ELIMINATION OF ARBITRARY INTERMEDIATE PIPE BREAKS
HOPE CREEK GENERATING STATION
DOCKET NO. 50-354

Public Service Electric and Gas Company requests approval for the Hope Creek Generating Station to eliminate the postulation of intermediate pipe breaks as specified by SRP 3.6.2 Sections II.1 and II.2 unless such locations exceed the stress and usage factor threshold levels provided in BTP MEB 3-1 or are located in the proximity of welded pipe attachments.

In addition to the above information, attached for your review are proposed FSAR changes to Sections 1.11 and 3.6 eliminating the postulation of arbitrary pipe break locations. These changes will be incorporated upon approval of the above request.

FIGURE 3.3-32 AMENDMENT 9, MAIN

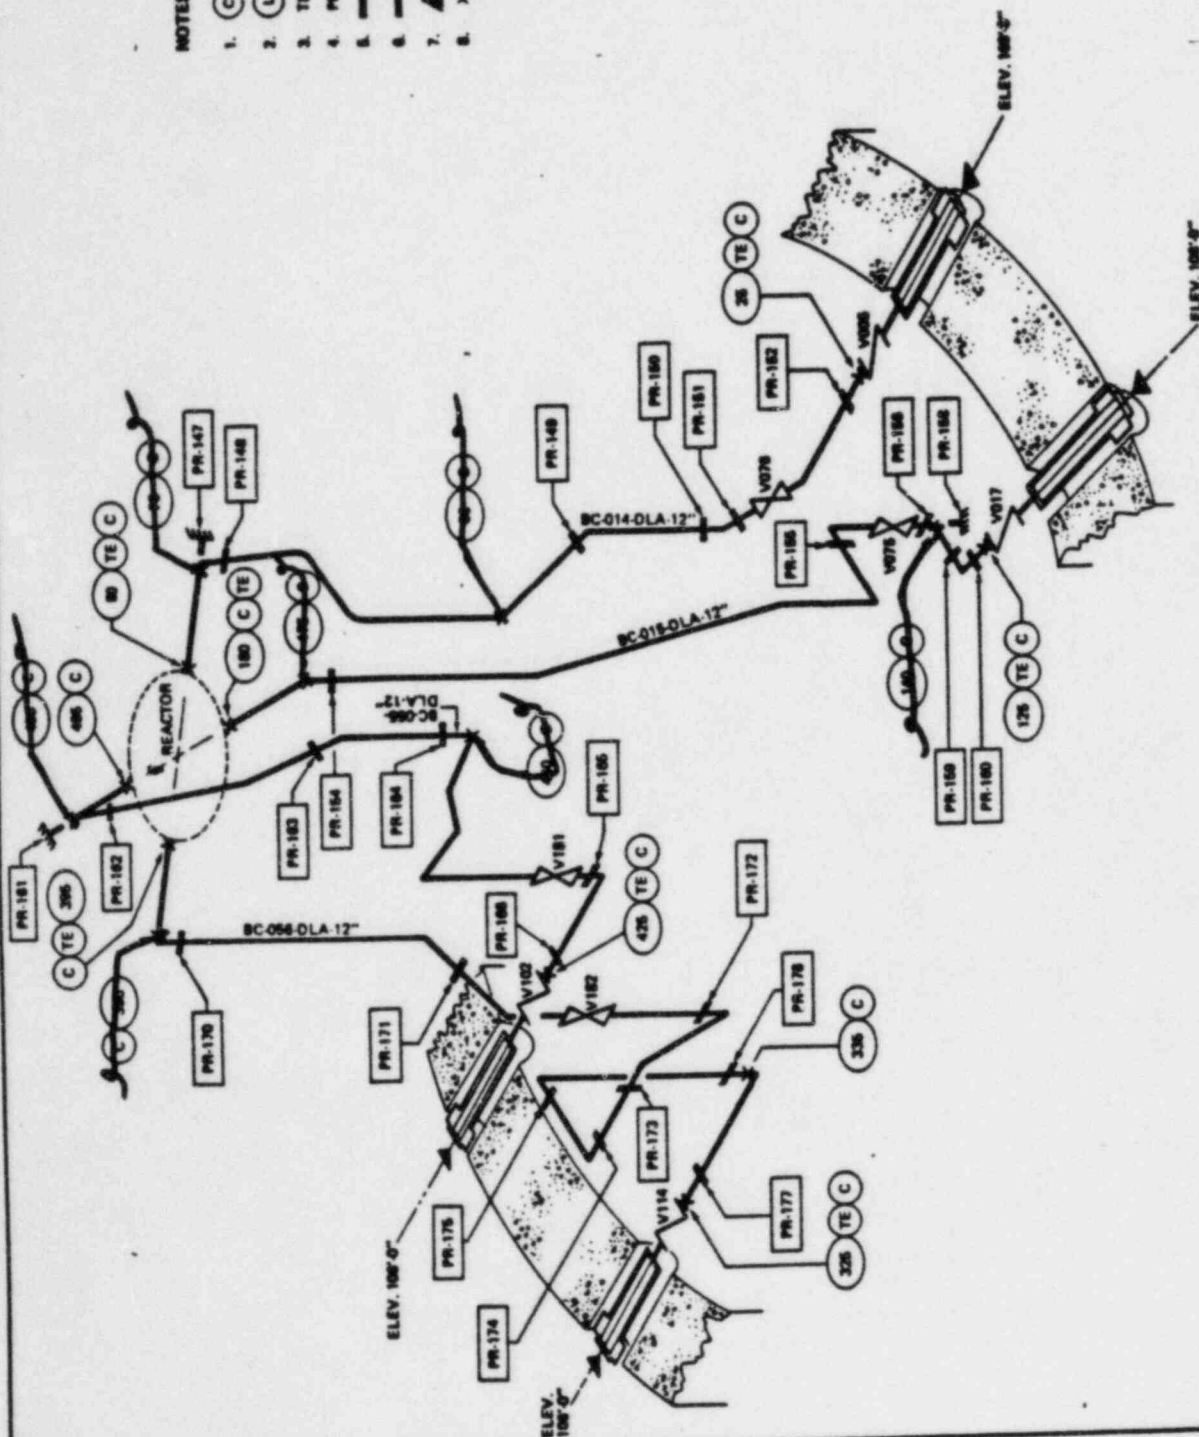
Node Point(1)	Node Type(2)	Stress By EQ. 10 (ksi)	Cumulative Usage Factor	Pipe Break Stress Limit 2.4 Sm (ksi)	Break Type(3)	Basis for Break Selection(4)
Line 12"-DLA-014						
80	TTJ	110.9 65.29	0.3047 0.0389	42.864 42.48	C	TE
75	EL	89.5	0.0494	42.864	C	SFL
60	EL	57.2	0.0035	42.864	C	SFL
25	TTJ	36.821 27.59	0.0142 0.0010	42.864 42.48	C	TE
Line 12"-DLA-015						
180	TTJ	110.37 63.06	0.2903 0.0303	42.864 42.48	C	TE
175	EL	82.83	0.0306	42.864	C	SFL
140	EL	39.03	0.0008	42.864	C	SFL
125	TTJ	36.205 28.27	0.0029 0.0008	42.864 42.48	C	TE
Line 12"-DLA-055						
495	TTJ	109.38 62.73	0.2878 0.0292	42.864 42.48	C	TE
490	EL	86.05	0.0408	42.864	C	SFL
460	EL	49.312	0.0012	42.864	C	SFL
425	TTJ	39.64 25.93	0.0045 0.0006	42.864 42.48	C	TE
Line 12"-DLA-056						
395	TTJ	108.99 58.86	0.2614 0.0233	42.864 42.48	C	TE
390	EL	85.06	0.0840	42.864	C	SFL
335	EL	47.83 39.30	0.0010 0.0008	42.864 42.48	C	SFL
325	TTJ	38.78 28.25	0.0037 0.0007	42.864 42.48	C	TE

MBL - Intermediate break locations selected to satisfy the requirements for a minimum number of break locations, *where such locations are in the proximity of welded attachments.*

CORE SPRAY INJECTION
PIPING ISOMETRIC
W/IN-DE CONTAINMENT
FIGURE 2.8-22
AMENDMENT 6, 06/06

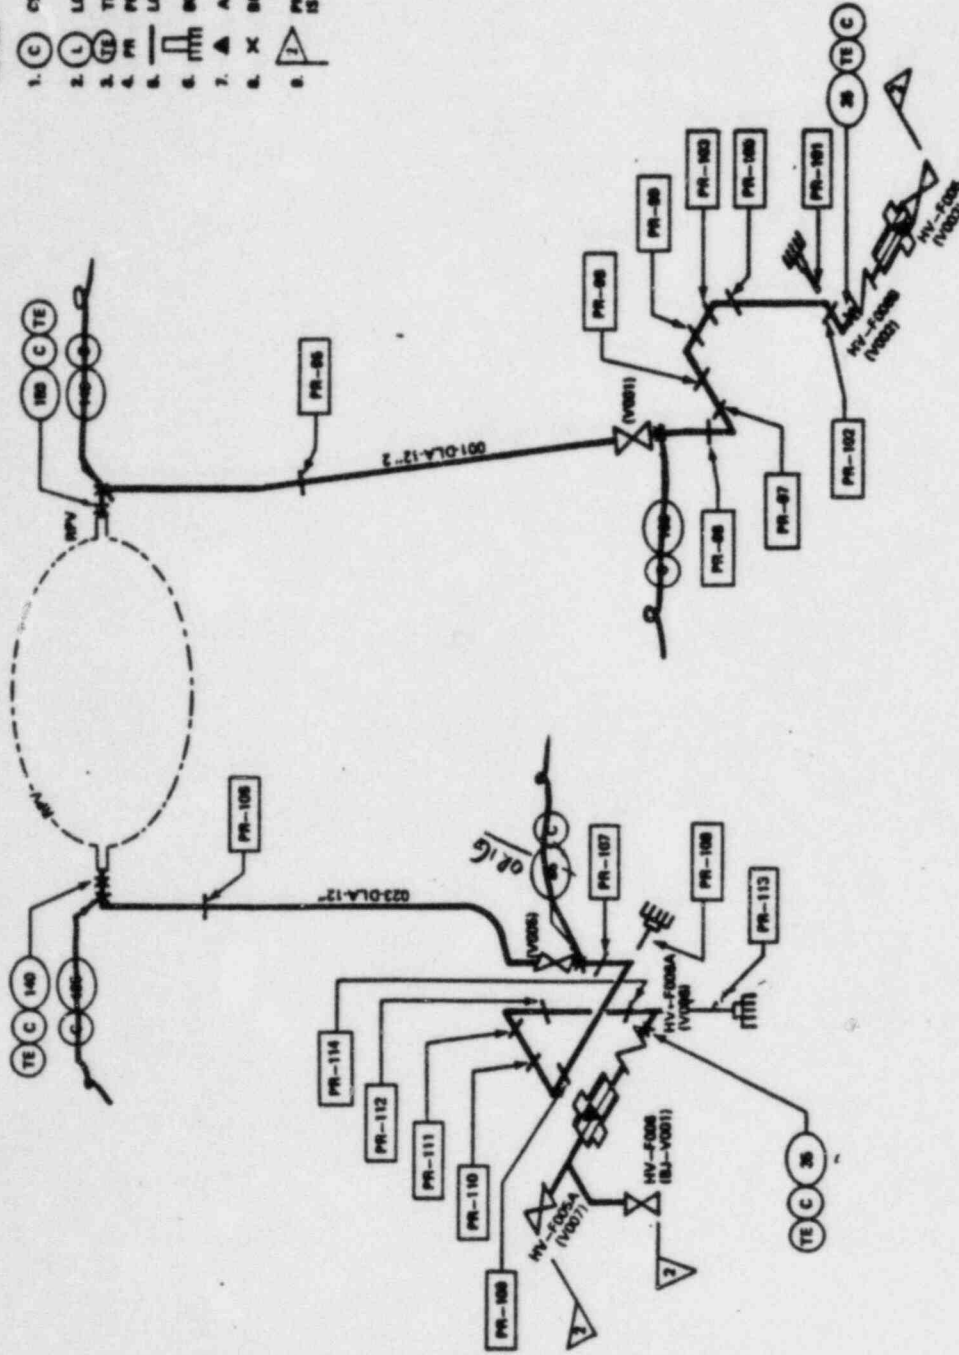
Node Point(1)	Node Type(2)	Stress By EQ. 10 (ksi)	Cumulative Usage Factor	Pipe Break Stress Limit 2.4 Sm (ksi)	Break Type(3)	Basis for Break Selection(4)
Line 12" - DLA-001		47.07	0.013	42.48		
150	RED	83.03	0.069	42.86	C	TE
145	EL	69.92	0.055	42.86	C	MBL
105	TTJ	37.63	0.0016	42.86	C	MBL
35	TTJ	25.39	0.0004	42.86	C	TE
		24.23	0.0003	42.48		
Line 12" - DLA-023						
140	RED	48.32	0.016	42.48	C	TE
135	EL	Later (3/85)	Later (3/85)	42.86	C	MBL
85	TTJ	(3/85)	(3/85)	42.86	C	MBL
35	TTJ	(3/85)	(3/85)	42.86	C	TE
		26.49	0.0004	42.48
